REMARKS

Appl. No. 10/805,824 Amdt. Dated August 15, 2007 Reply to Office Action of March 29, 2007 ANNOTATED SHEET SHOWING CHANGES

FIG. 2

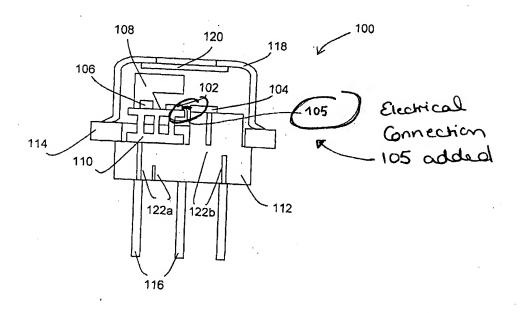
The Examiner also suggested amending Fig. 2 to depict an electrical connection from the upper portion of the upper surface of the substrate to the laser light source, and to amend the Abstract to conform to the language of independent claim 25 as amended.

Changes to Fig. 2 and to the Abstract have, as a result, been made in the instant Amendment. The changes to Fig. 2 submitted herein include the depiction of the electrical connection or "leads" mentioned in paragraph [0020] of the original specification. To the extent that the electrical connection is being added herein to Fig. 2 and supplied with a reference numeral "105" therein, paragraph [0020] of the specification is being sought to be amended herein to specifically mention reference numeral "105" as corresponding to the "leads" mentioned in that paragraph.

The attached sheet of drawings includes changes to Fig. 2. This sheet, which includes only Fig. 2 thereon, replaces the original sheet including Fig. 2. In Fig. 2, the previously omitted electrical connection from the upper portion of the upper surface of the substrate to the laser light source has been added.
